TOWN OF COTTESLOE

BEACH ACCESS PATHS COMMITTEE MEETING

MINUTES

8 REPORTS**8.1 REPORTS OF OFFICERS****8.1.1 COMMUNITY ENGAGEMENT - NEW BEACH ACCESS PATHS AND BEACH ACCESS PATHS WORKS**

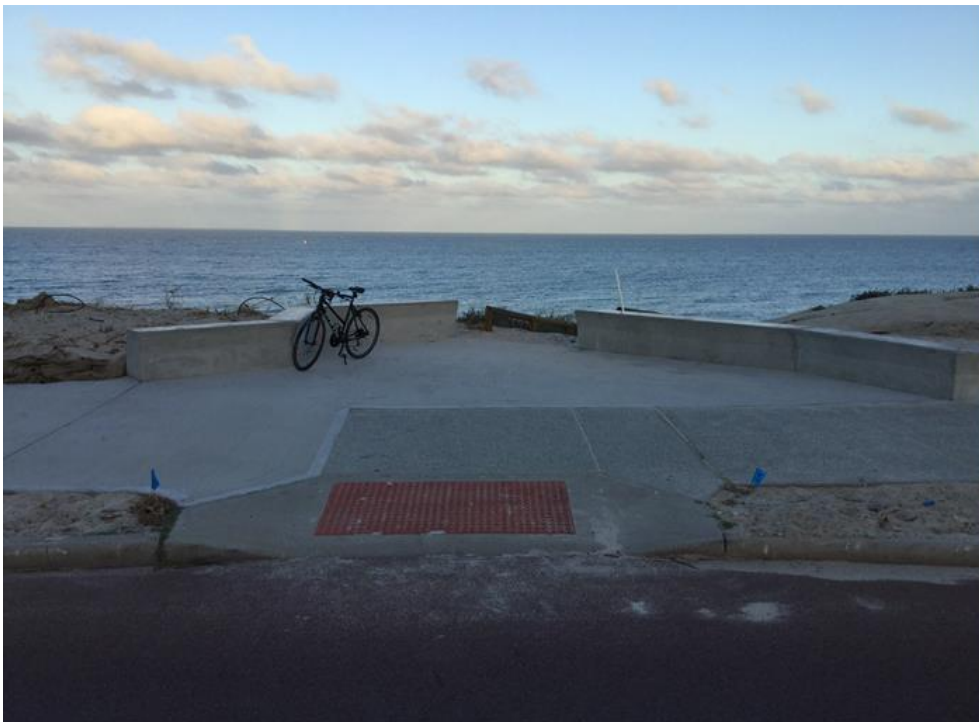
1. Could you please advise what the white pipe is at N6?

2. Here is the existing small concrete area that provides a transition between Marine Pde and the pedestrian path. As said in my previous email (below) the Softworks plan shows the existing sand area either side of the path (with blue flags) that I understand will not be concreted.

The white piping in the pictures below located at N6 is a reticulation piping.

Correct this will be planting, no additional concrete is being added to the crossover and the blue flags are the reticulation markers

ITEM 8.2.1A: BEACH ACCESS PATHS N7 TO N6 VERGE

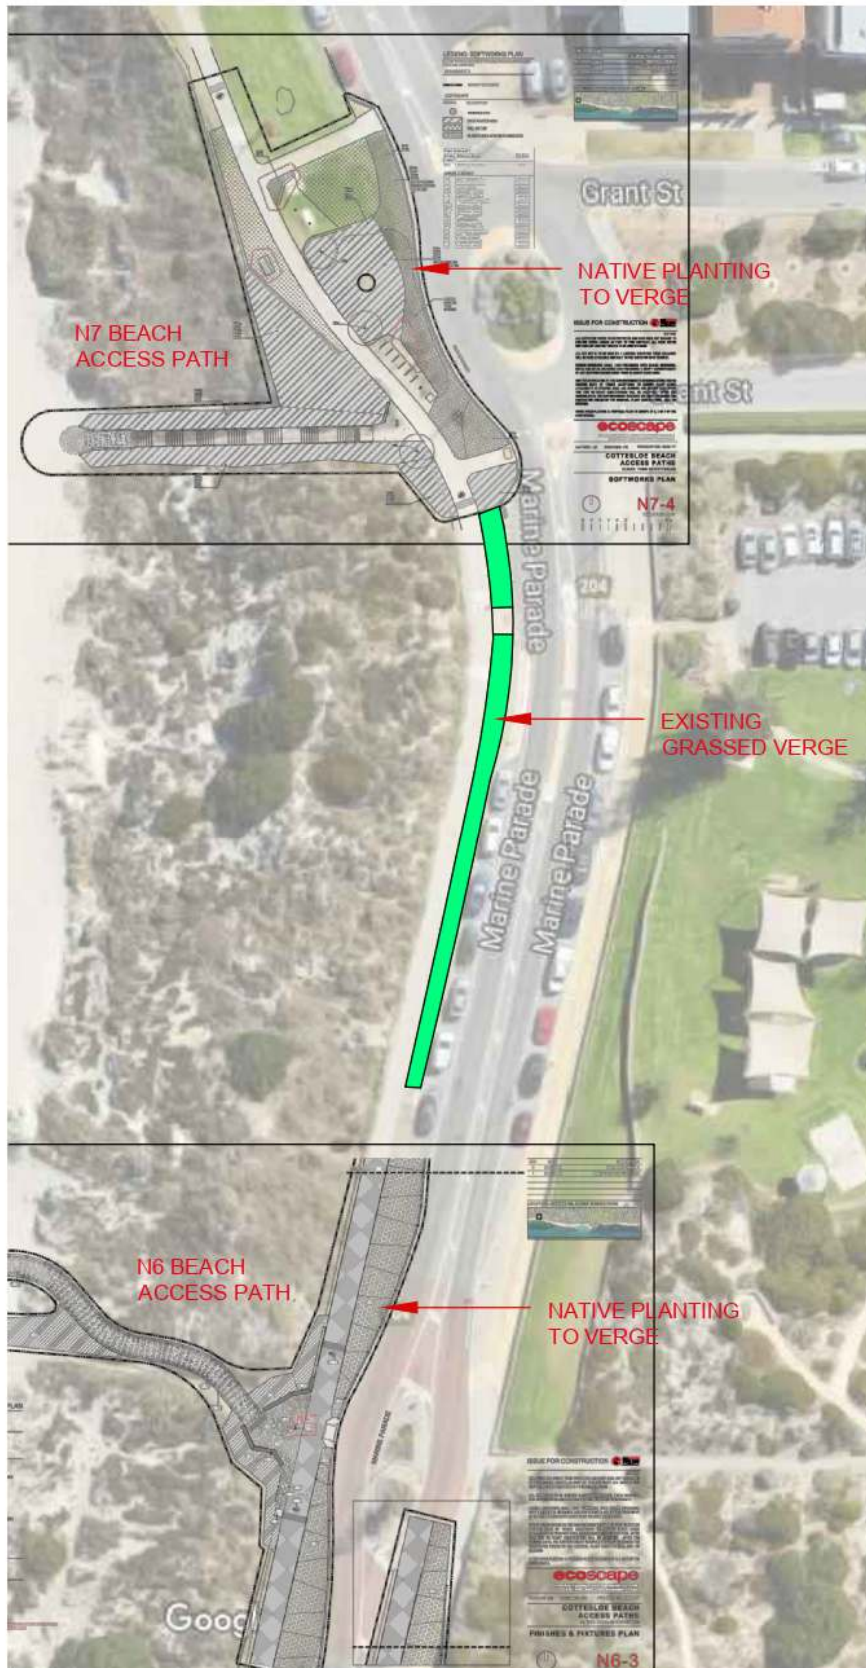
At the last BAP Committee Meeting 6 March 2019, I introduced an Agenda Item regarding the reticulation and planting of the strip bounded by Marine Pde, pedestrian path, N6 and N7 and I recall you advised Committee Members that this would be a grassed area.

Attached is a marked up drawing showing the extent of the existing grassed verge to remain. I have also overlaid the N6 and N7 plans showing the extent of native planting at each node.

1. Can you please confirm that the subject strip, denoted on the attached N6 plan as a "PLANTED AREA WITH MULCH (IRRIGATED)", will be planted with grass or coastal species?

2. Can you please confirm that the planting either side of the short concrete "entrance path" from Marine Pde to the pedestrian path (as shown on attached N6 plan) will be the same concrete area as currently exists on site?

The N6 plan (attached) shows an increase in concrete area either side of this subject short section of path.

Native planting is nominated for the verge where planting is shown on the drawings.

This is correct the pedestrian crossover is not being widened as per the onsite discussions
